Value Engineering Study

Final Report

Kentucky Transportation Cabinet I-71 Widening, MP 14.1 to MP 18.0 Oldham County

Item No. 5-483.10

I-71 SB Bifurcated SW Leg - VE Proposal

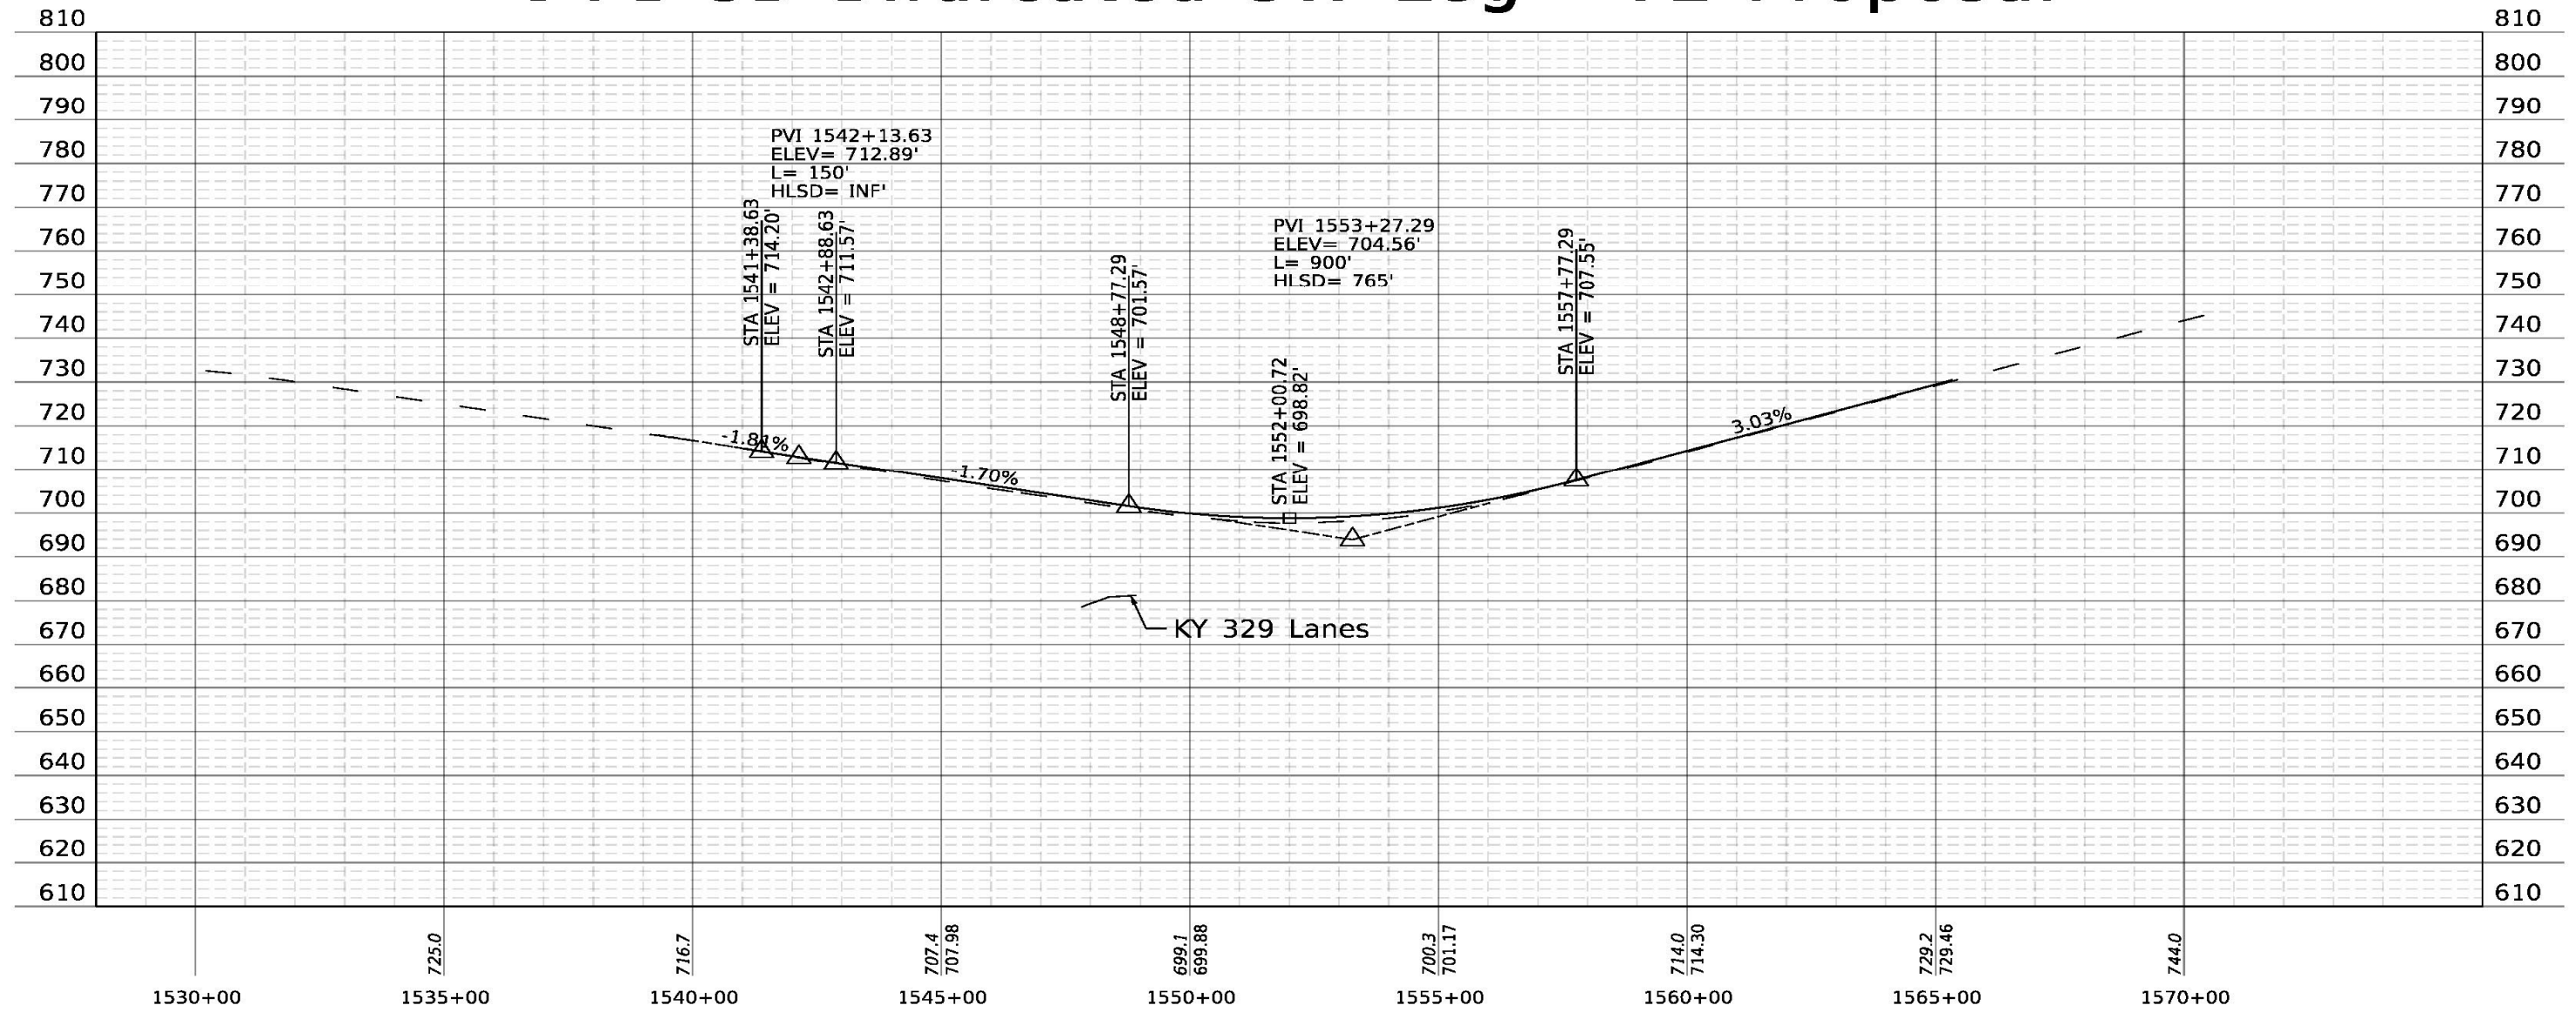
TITLE		Reduce vertical clearance on KY 329 from 16' to 14'-6"			
FUNCTION		Miscellaneous			
VE PROPOSAL SYNOPSIS:					
KYTC policy allows for routes not on an interstate highway and not on the Strategic Highway Network to have bridge clearances as low as 14.5'. Eliminate the grade revision on I-71 meant to achieve 16.5' clearance on KY 329 and instead widen near existing grade to achieve 14.5' allowed by KYTC.					
	Reliability	Maintained		Functionality	\$ Initial Cost Avoidance (Add)
	O&M	Maintained		Schedule Impact	
BASELINE CONCEPT DESCRIPTION:					
Adjust grade of bifurcated section of I-71 at the interchange with KY 329 to achieve a desired 16.5' vertical clearance at the bridge over KY 329.					
VE PROPOSAL DESCRIPTION:					
VE PROPOSAL ADVANTAGES:			VE PROPOSAL DISADVANTAGES:		
● Simplifies maintenance of traffic			● Lower bridge clearance		
● Reduces leveling and wedging need			●		
● Reduces embankment needed			●

The baseline design proposes to improve the sag vertical curves on I-71 at KY 329 to provide 16.5' of clearance on KY 329. The current clearance on KY 329 is 13.5' with haunched girder bridges carrying I-71 over KY 329. The value team proposes to reduce this clearance to 14.5'.

By reducing the proposed clearance, the constructability of mainline I-71 will be improved. The current baseline may prove difficult to maintain traffic on existing I-71 while raising the grade by 3'-4'. By reducing the amount of grade difference, the amount of shift needed to construct the new bridge is decreased. This will also reduce the total amount of pavement structure needed over the existing I-71 travel lanes to construct the grade change. It was unclear what material was being used to accomplish this grade change over the existing pavement. An assumption was made, based on the CAD files provided, that asphalt level and wedge would be utilized. By reducing the amount of grade change, a cost savings of over \$1,250,000 can be realized.

It also appears the proposed bridges on I-71 are wider than necessary to accommodate MOT in later phases when traffic is shifted onto the newly constructed bridge and approaches and work begins to complete construction of the new bridge and raise the existing lanes to the final grade. Additionally, the reduction of grade change will greatly simplify MOT schemes and provide additional cost savings that can be realized but are difficult to quantify in this proposal. MOT savings have not been included in this proposal.
